Subject: 2723 Brandon Road (CU-02-25) - Work Session review of a conditional use and variance for a proposed replacement Columbia Gas of Ohio utility station.

RE: Conditional Use 02-25; Columbia Gas Utility Station at 2723 Brandon Rd

RE: Major Site Plan 01-25; National Church Residences, 2233-2335 North Bank Drive

**FIRST FLOOR &
ROOF PLAN**

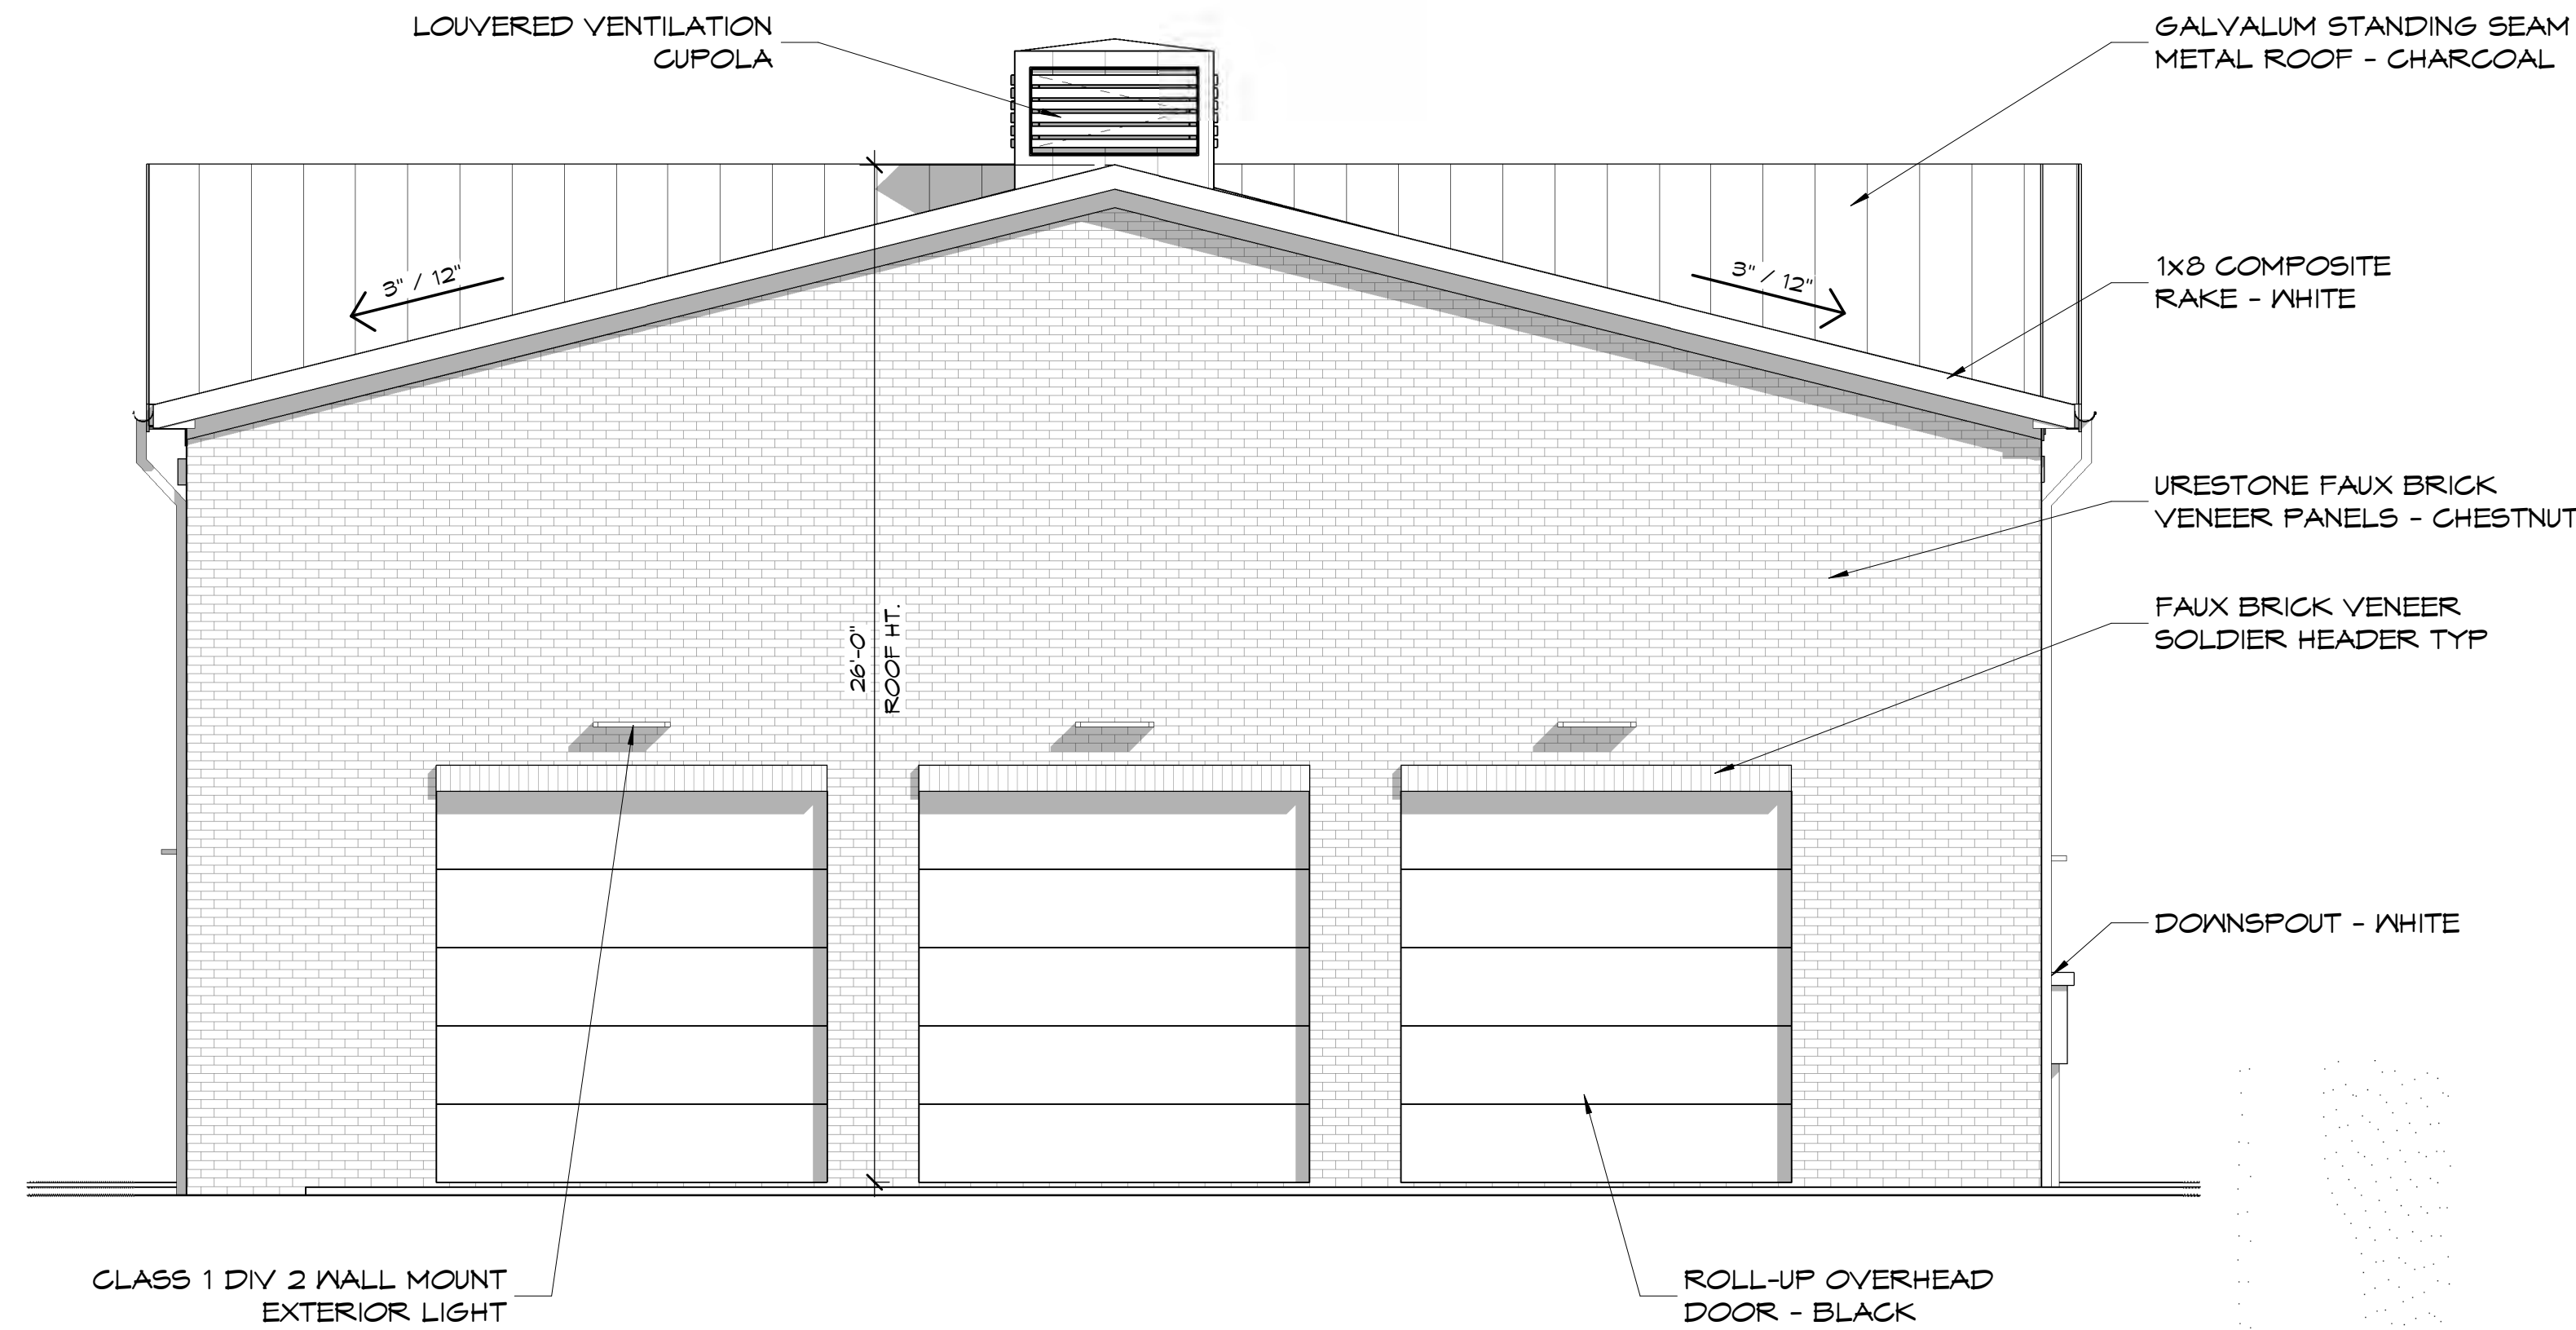
and columns will be revised to black to match the doors. This change should also be made for the Ridgeview station so they are unified in their design. Please provide the door specifications on the plans. Any visible piping on SCADA/RTU building shall not be glossy and is required to be screened with landscaping to 50 percent opacity.

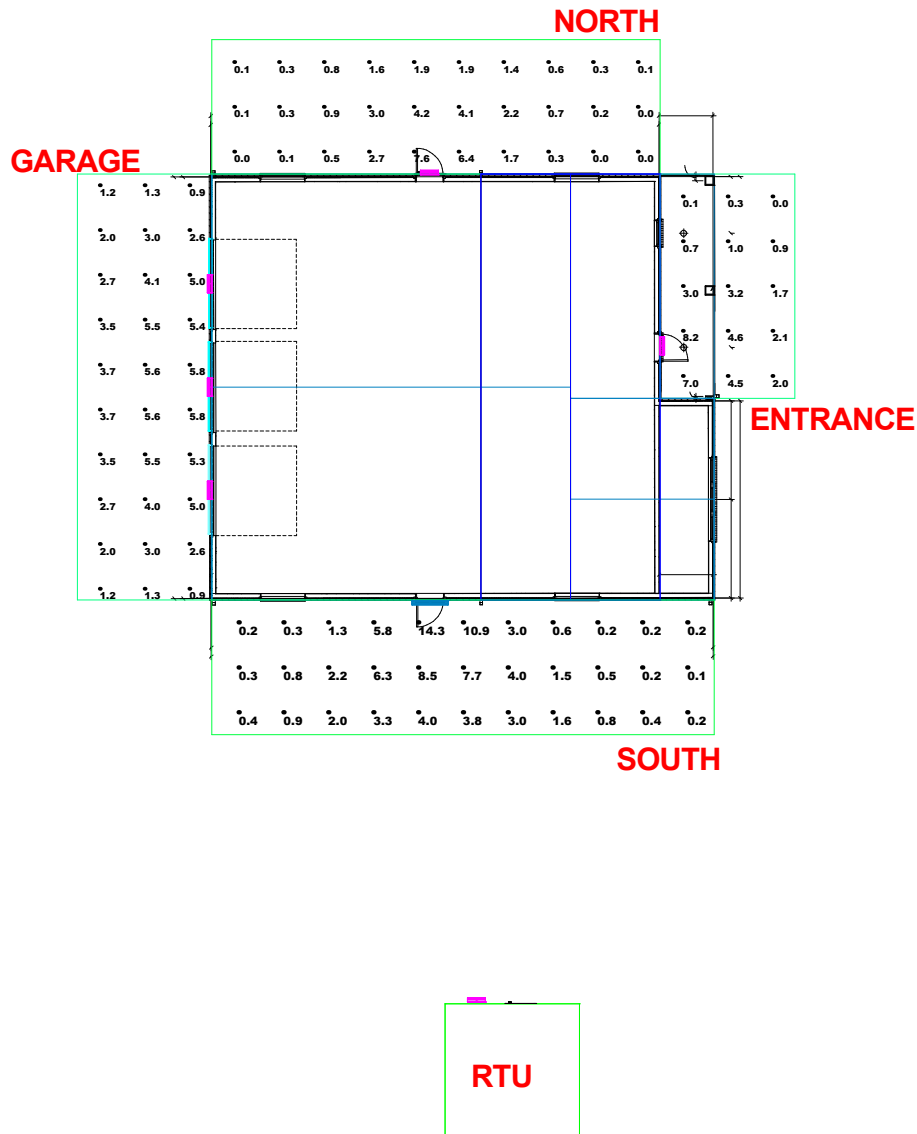
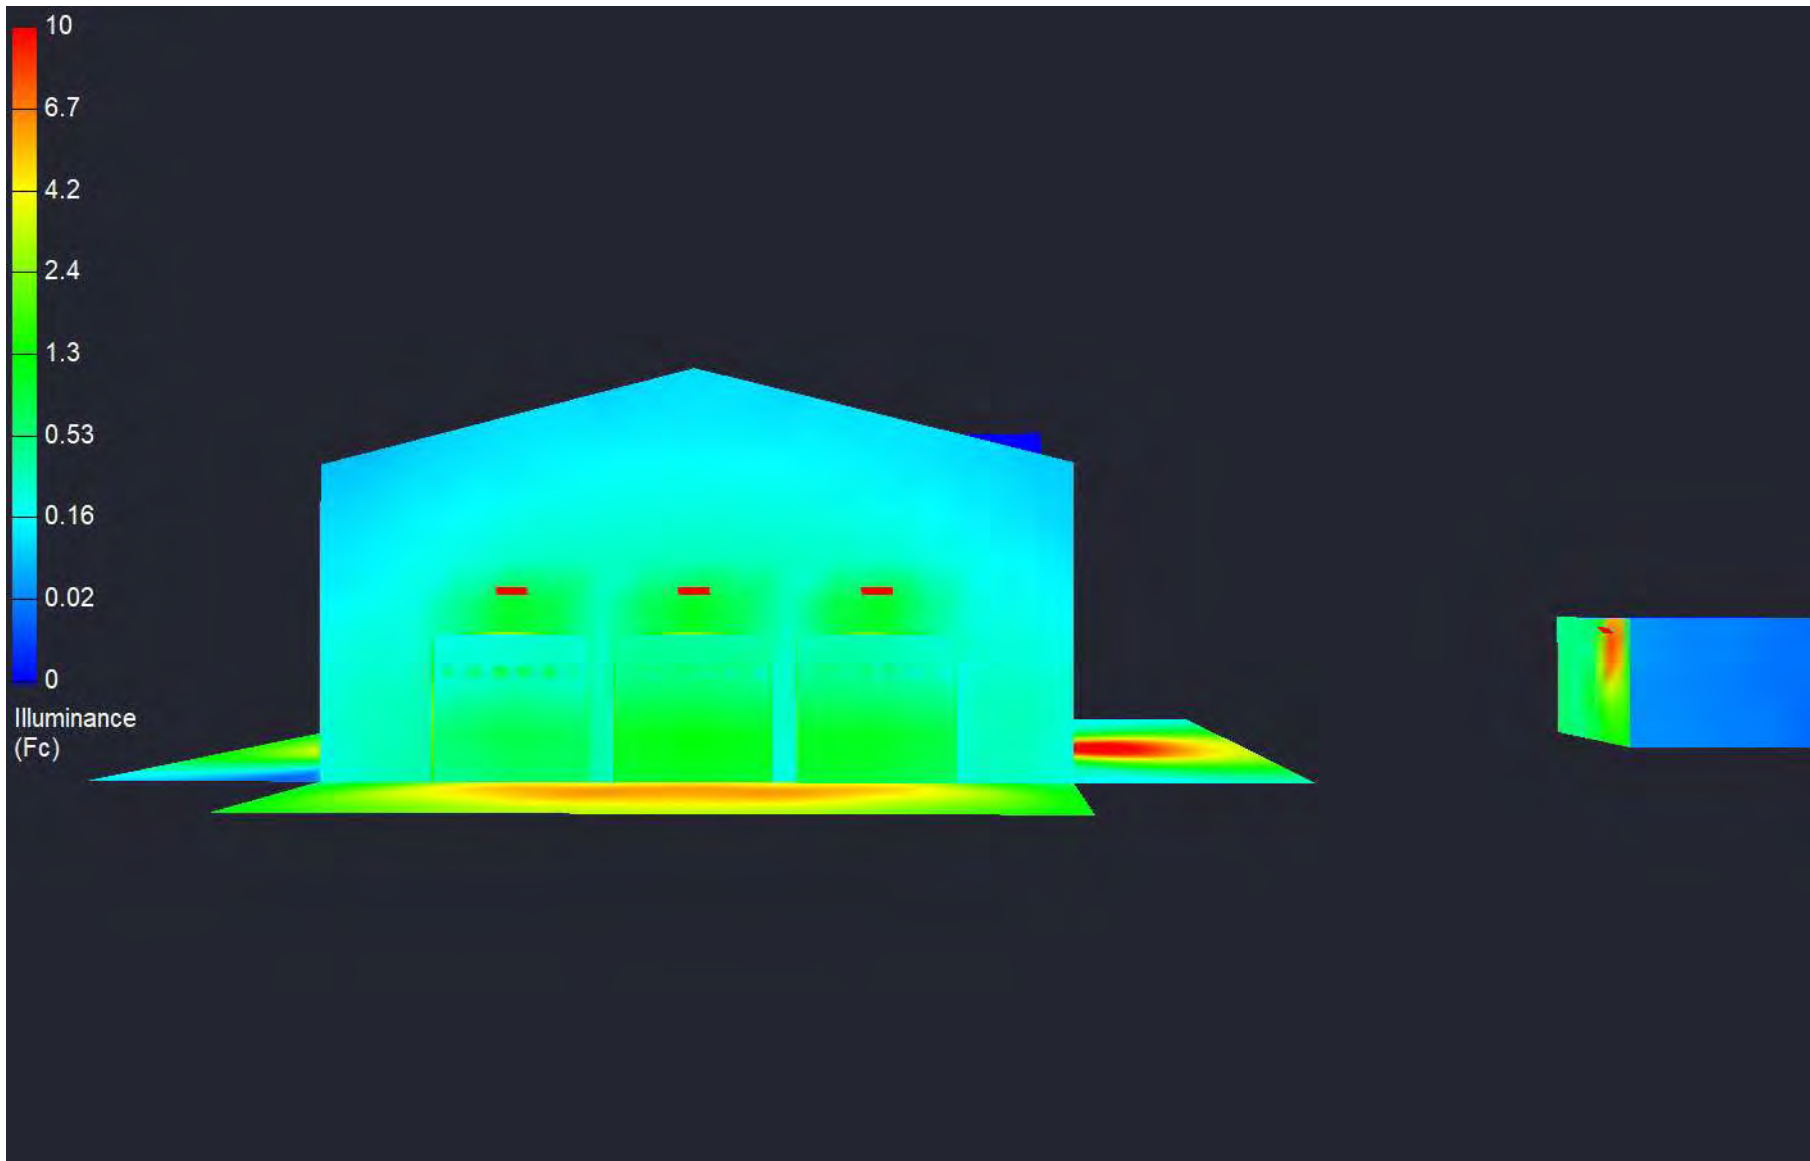
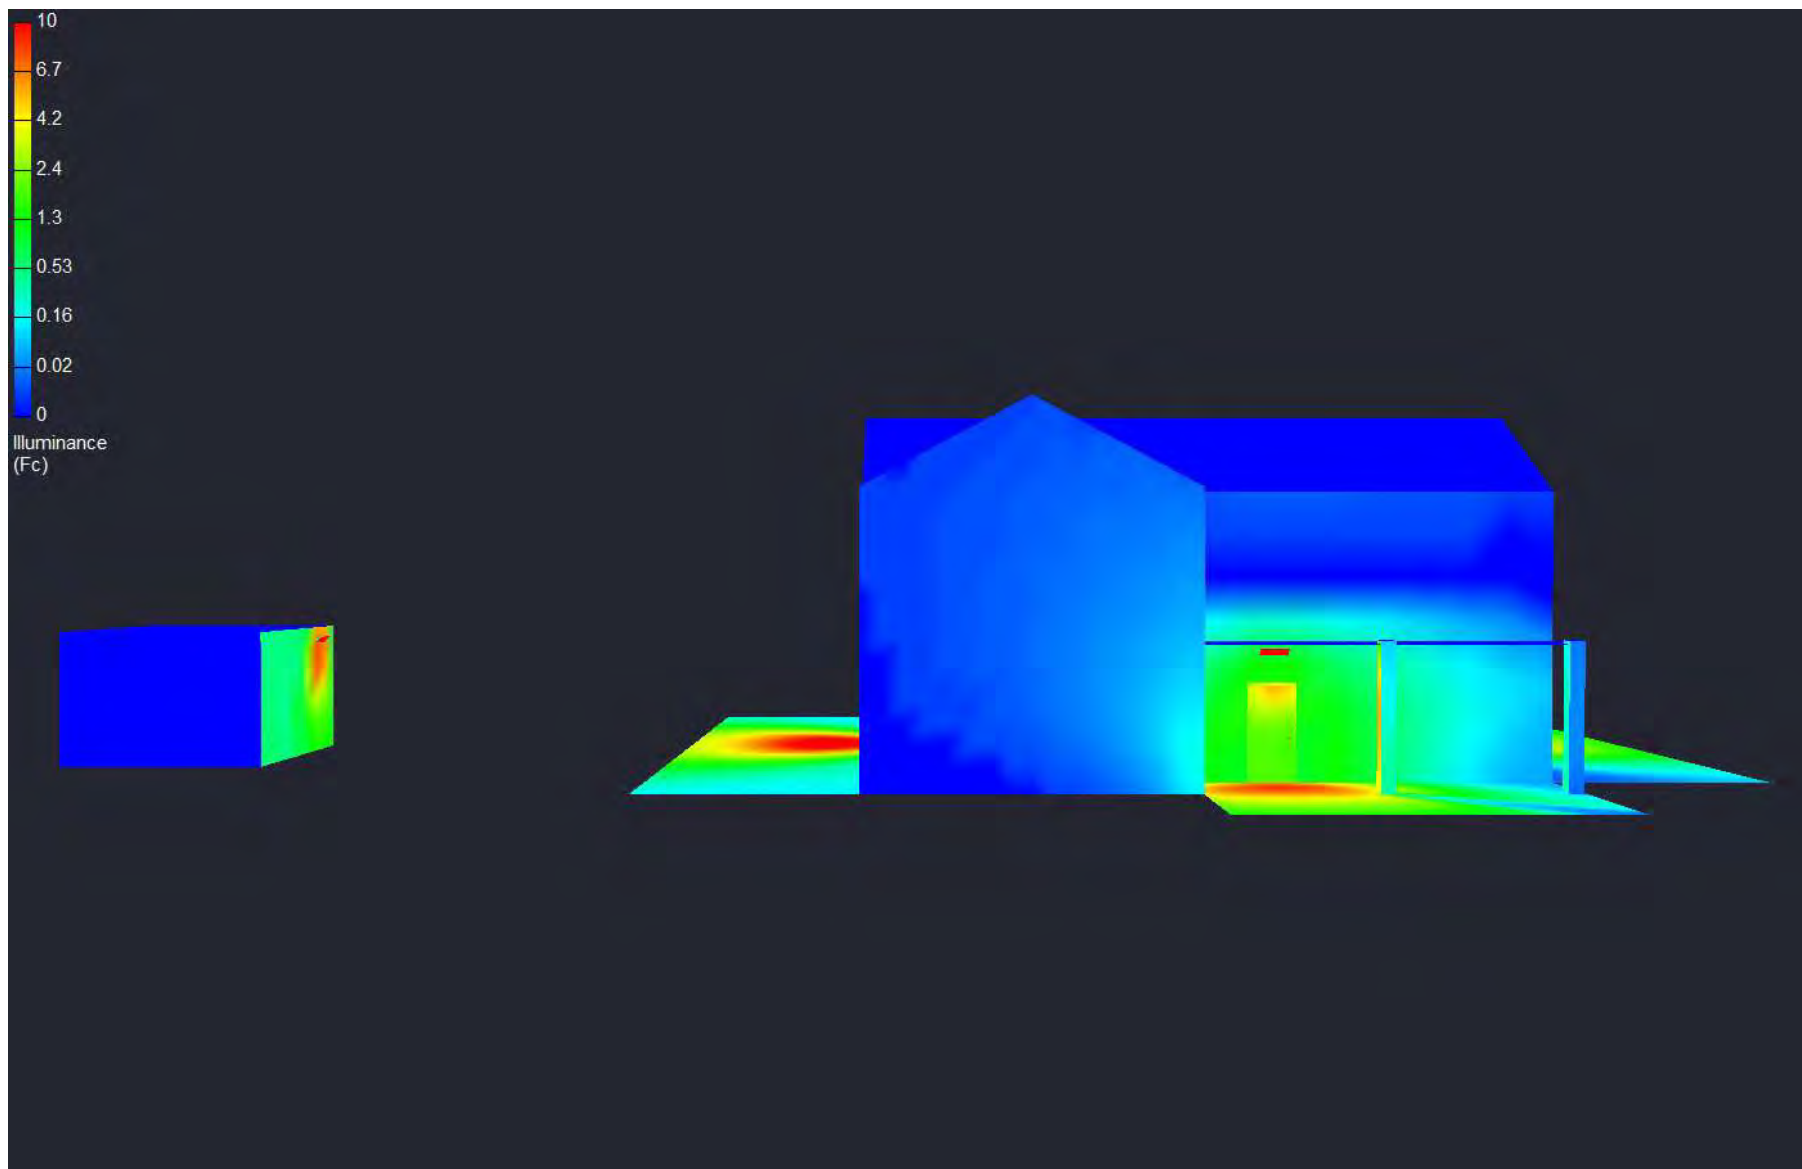
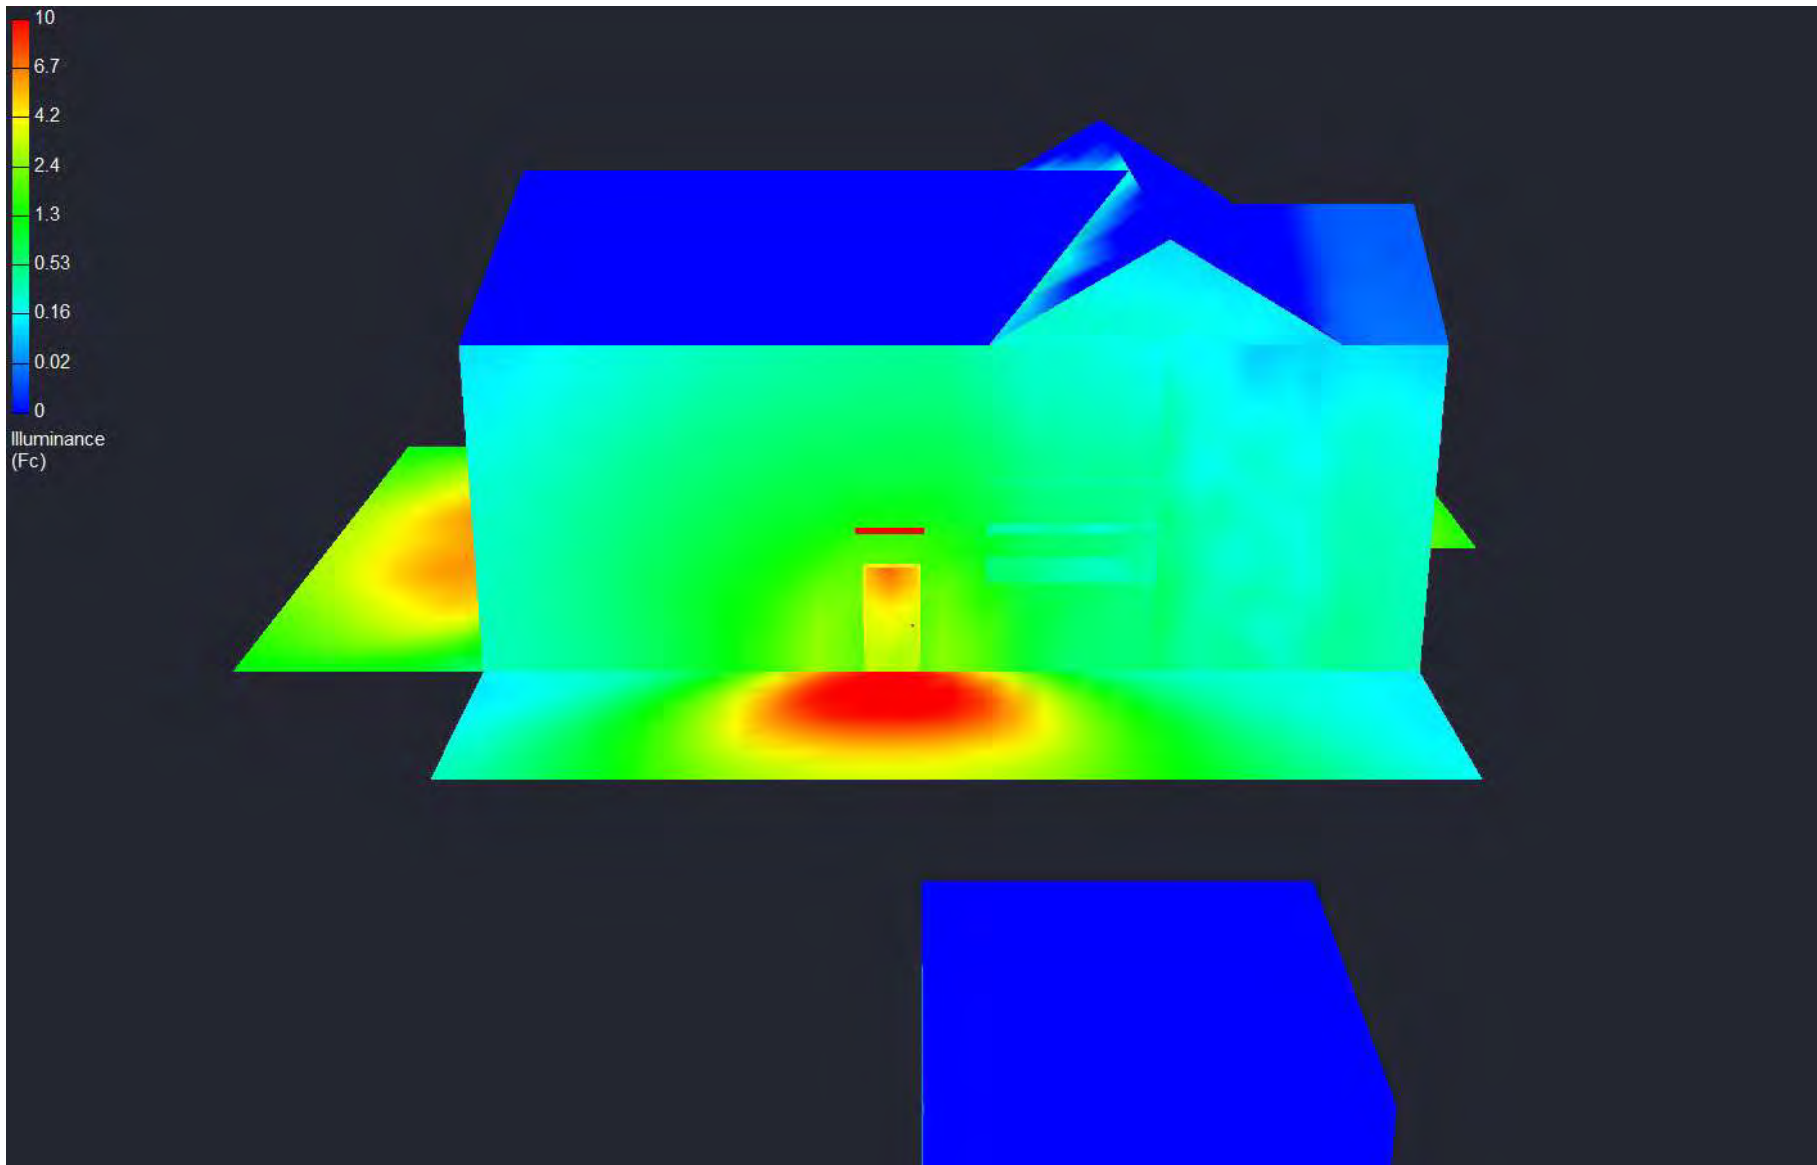
- 6) **Exterior Lighting** – To ensure compliance with the City's Dark Sky® standards, please show the footcandle values extending 15 feet beyond all property lines on the photometric plan. Please continue to look at reducing the hot spot at the front porch for the primary building. Please provide shielding (if possible) on all proposed light fixtures to direct the light down and avoid light spilling onto adjacent residential properties- recessed lighting is also an option.
